From: Andrew Leon
Sent: Tuesday, February 21, 2023 8:25 AM
To: Ryan Harriman
Subject: FW: Totally Against DSR22-014 Baskin Robbins Proposed 10-unit building

From: Sarah Fletcher <fletchsa1@gmail.com>
Sent: Sunday, February 19, 2023 7:04 PM
To: Andrew Leon <andrew.leon@mercerisland.gov>; Jeff Thomas <jeff.thomas@mercerisland.gov>; Planning Commission <Planning.Commission@mercergov.org>; Design Commission <Design.Commission@mercergov.org>
Subject: Totally Against DSR22-014 Baskin Robbins Proposed 10-unit building

Figure 2— Area of Required Retail, Restaurant or Personal Services Use Along Ground Floor Street

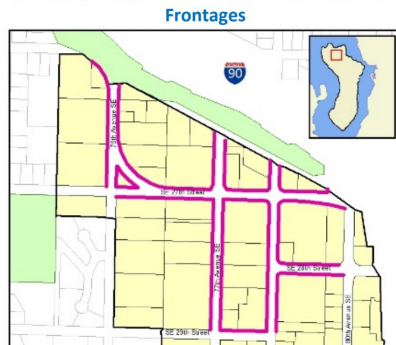
And it has where **RETAIL IS REQUIRED**, but the proposed building is not offering any retail. See map below:

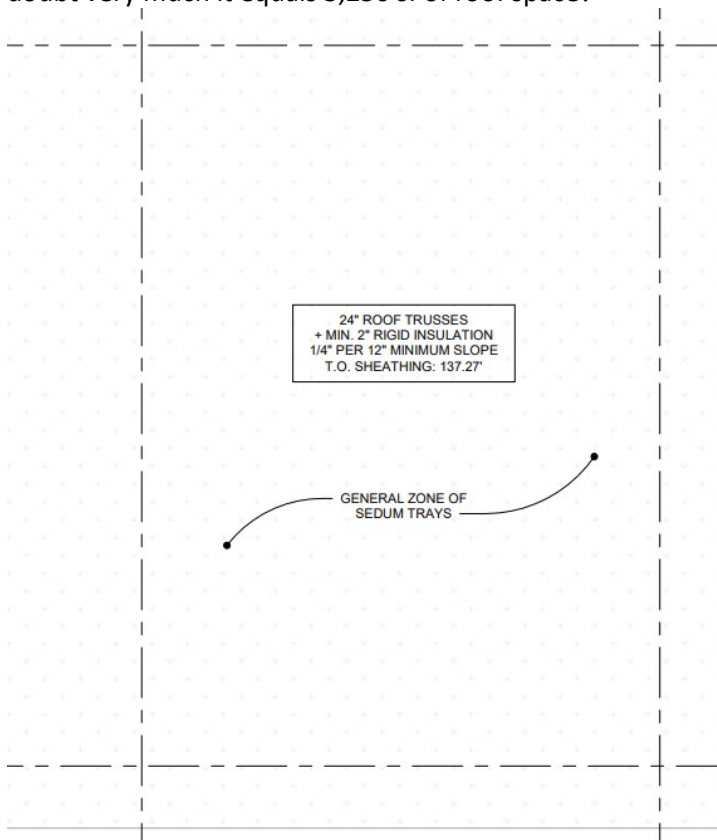
It says that 3,250 sf of sedum trays on the roof, but if you look at the plans on page 7, it does not show 3,250 sf of sedum trays, it shows a portion. And are you trying to say, that they can go across the road, buy a few trays of sedum and put them on the roof, and that is sufficient?

As I am a layman and don't know how to read plans, how much exactly is it showing? I

If you look at the plans, it has a section of the roof as for the sedum trays on a portion and not even on the whole roof, I doubt very much it equals 3,250 sf of roof space?

Is the roof going to be sloped or flat? It is hard to tell.
